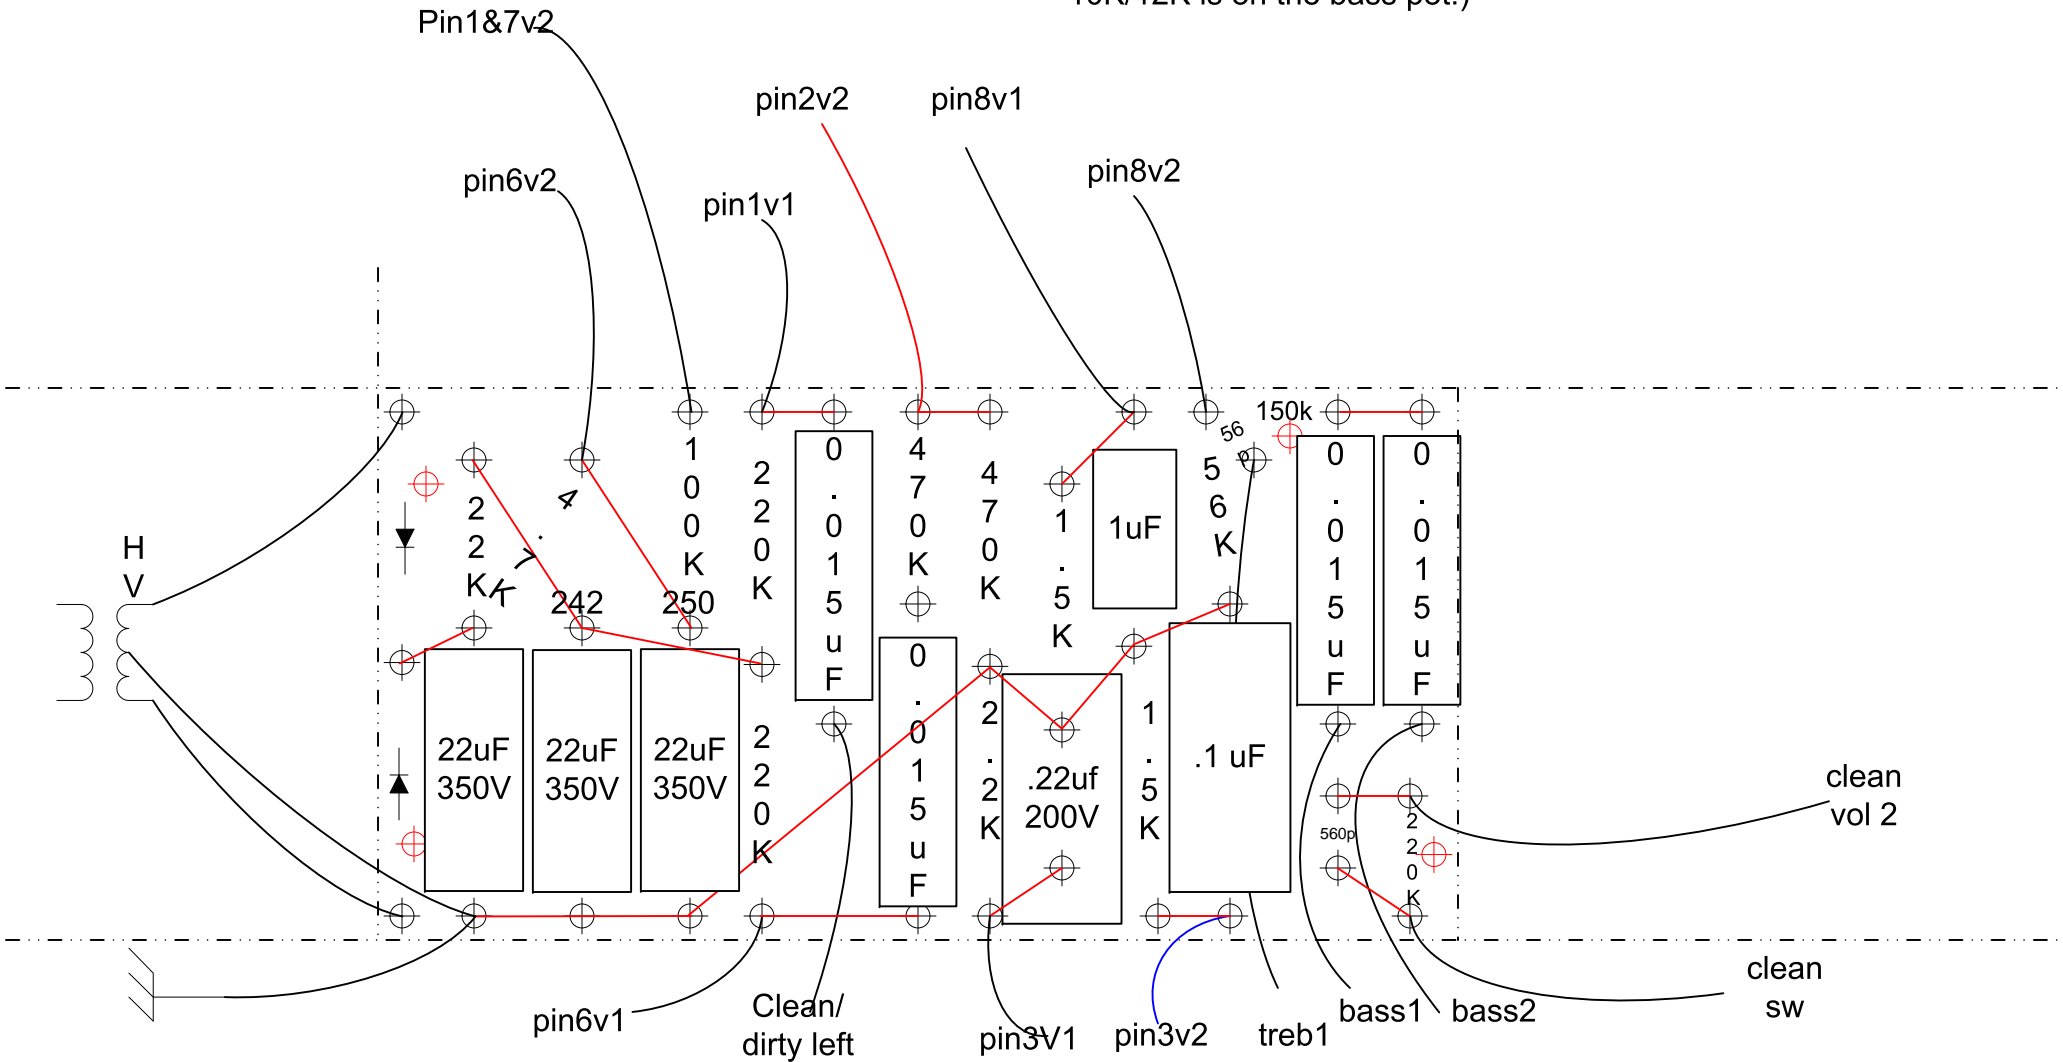
Change 10K and 100K resistors in
Vox tone stack to 12K and 150K to
compensate for change in caps. (The
10K/12K is on the bass pot.)
